NO: CON-053
DATE: July 2013

PRODUCT: XS2/3□-M*** series Industrial Connector
TYPE: Product Modification Notice

Product Modification Notice: XS2/3□-M*** series Industrial Connectors

< Cover >

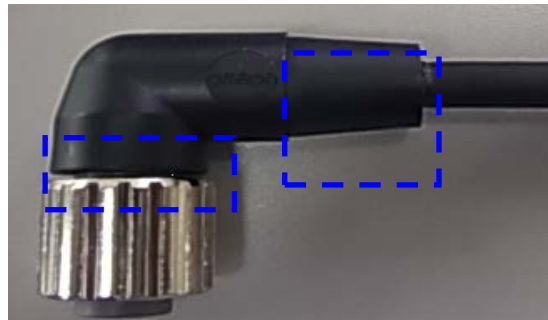
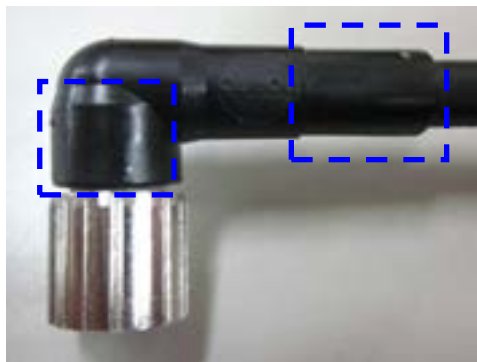
Omron announces the modification of the **XS2/3-M*** series Industrial Connectors**. The cover shape and cable printing will change. Please read the entire contents of this announcement for complete details and specification changes. Should you have any questions or require additional technical support, please contact your Omron Sales and Marketing teams.

Changes (The picture represents the printing method; Part number displayed is just an example)

Before the change

After the change
